ADDENDUM #2

EAST HARTFORD MULTI-USE TRAIL Bid No. 16-02 TOWN OF EAST HARTFORD

July 13, 2015

The following summarizes the revisions to the Bid Documents included in Addendum #2 for the East Hartford Multi-Use Trail Project (Bid No. 16-02).

REMOVABLE BARRIER POST
NTS

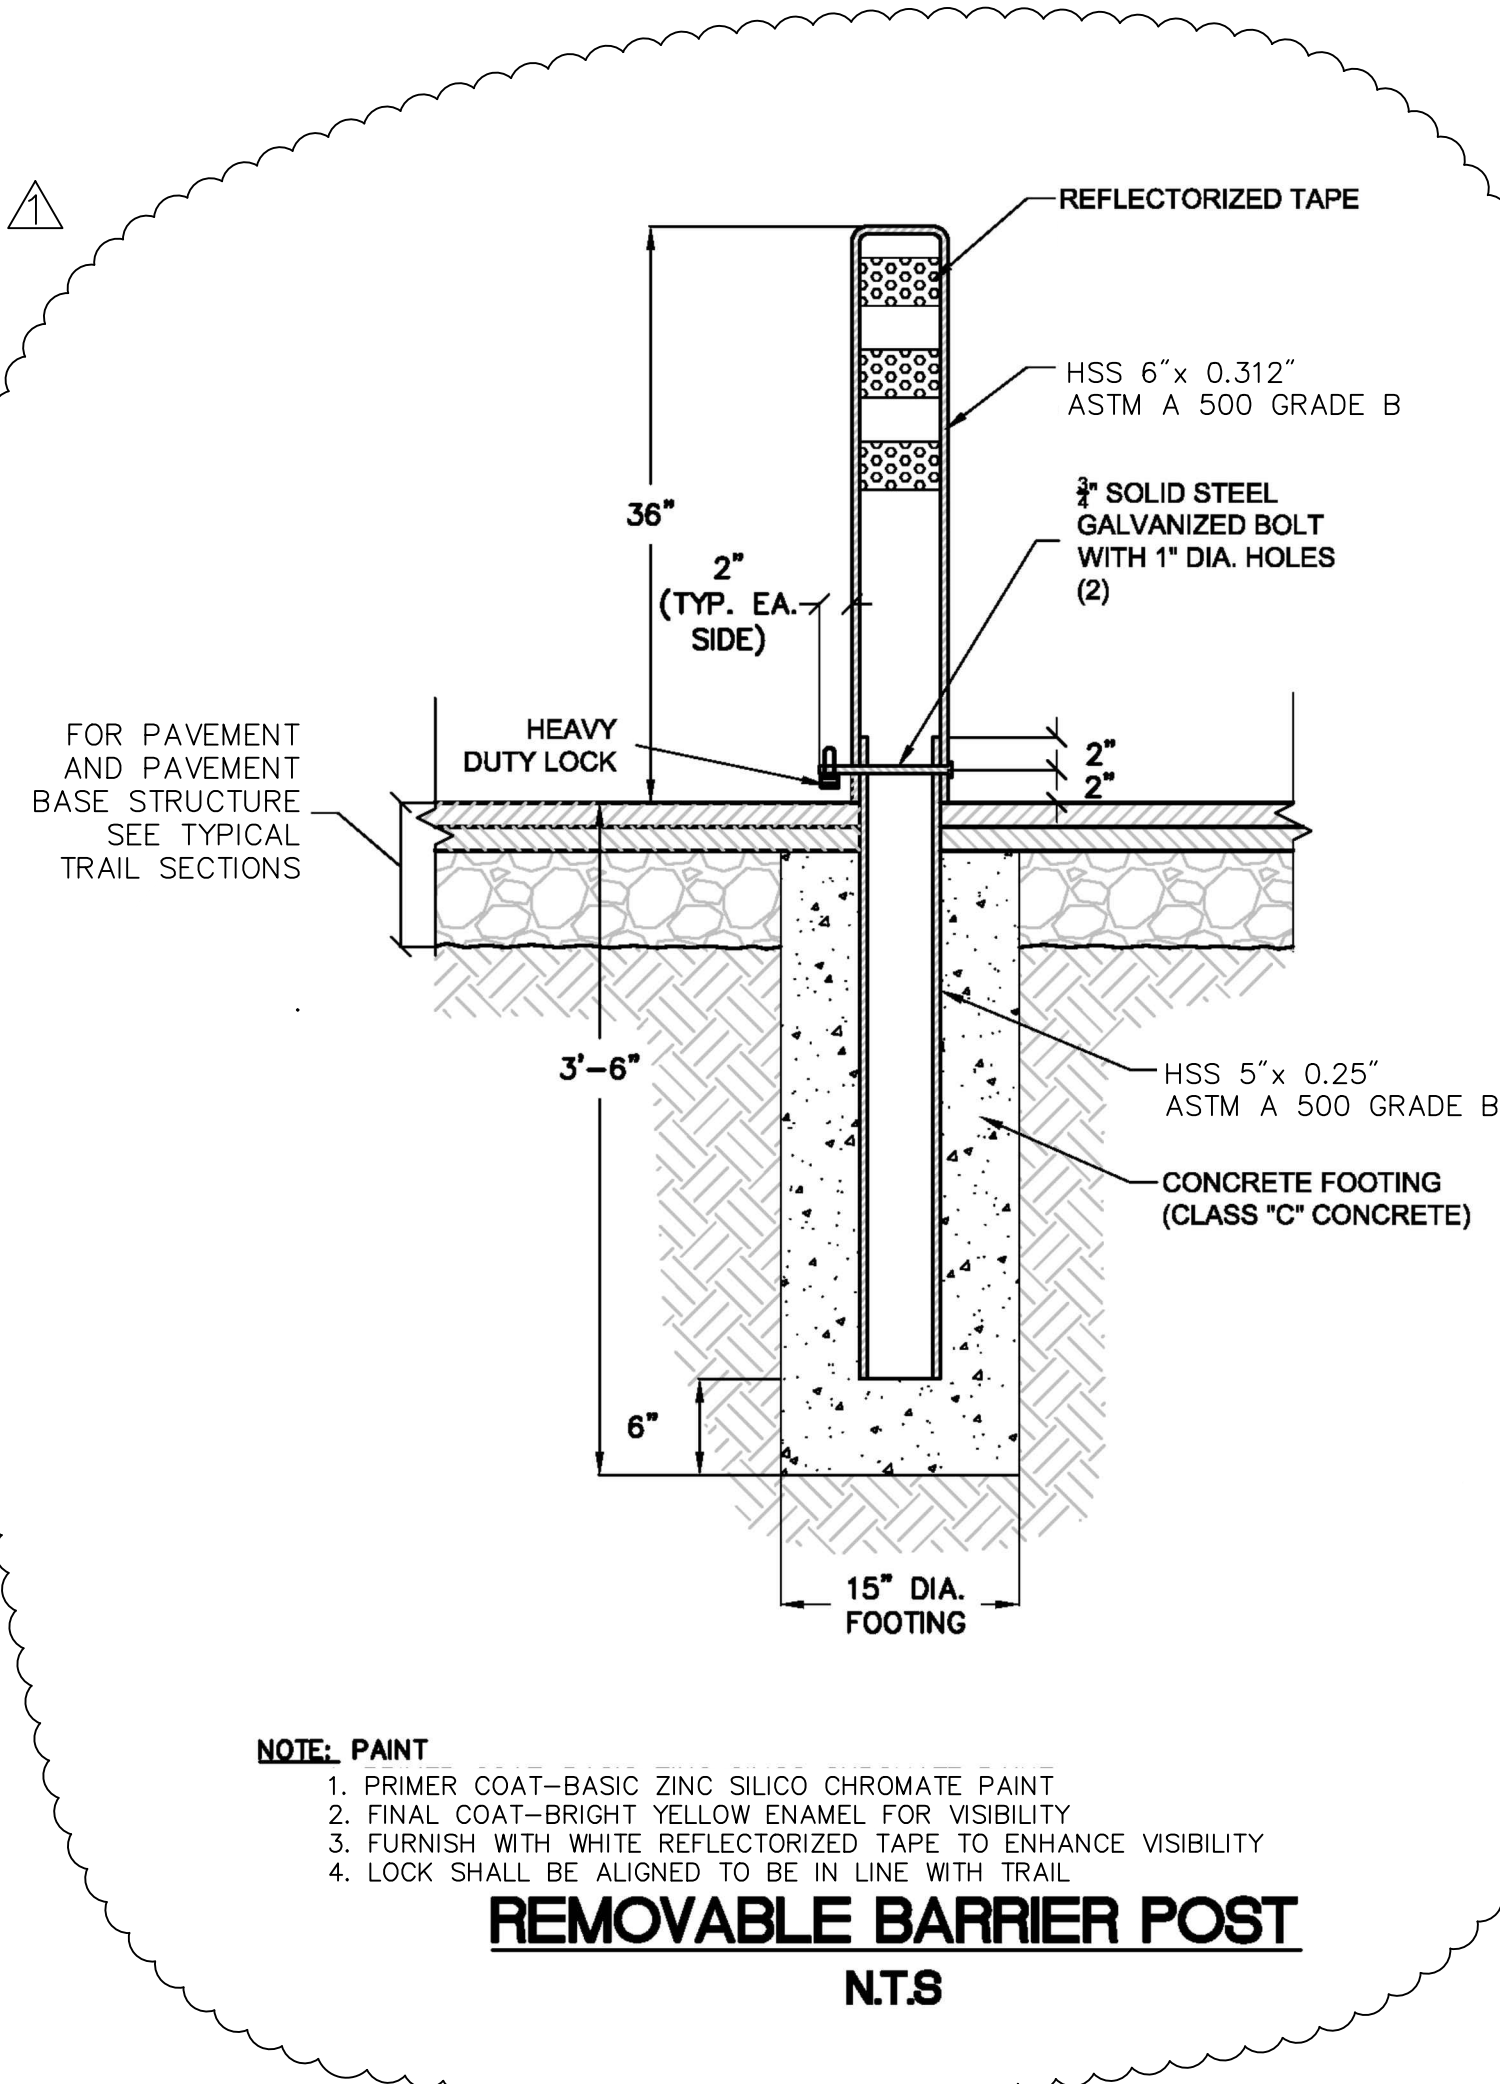
- Add Special Provision for Item #0520038A
- Replace third page of bid sheets to reflect revised Item # 0520038A (page 29 of 627)
- Replace special provision for Item #0906202A to reflect revision to type of fasteners
- Replace special provision for Item #0906203A to reflect revision to type of fasteners
- Replace sheet S-3 to reflect the removal of the wood rail fence notes.
- Replace Sheet MD-1 to reflect revisions to type and size of steel tubes for Removable Barrier Post.

Item 0901004A Removable Bollard Post: Please provide a vendor to supply TS 5-1/8" x 1/4" for embedded post fabrication per details or provide alternate manufactured tube steel sizes that will fit into each other. Would a prefabricated removable or hinged bollard be acceptable?

The tube sizes have been modified to HSS 6" x 0.312" and HSS 5" x 0.25". An updated plan sheet is attached. Bid should include bollard as specified.

7-15-15	REVISED BOLLARD DETAIL	10
REV.	DATE	DESCRIPTION
		REVISIONS
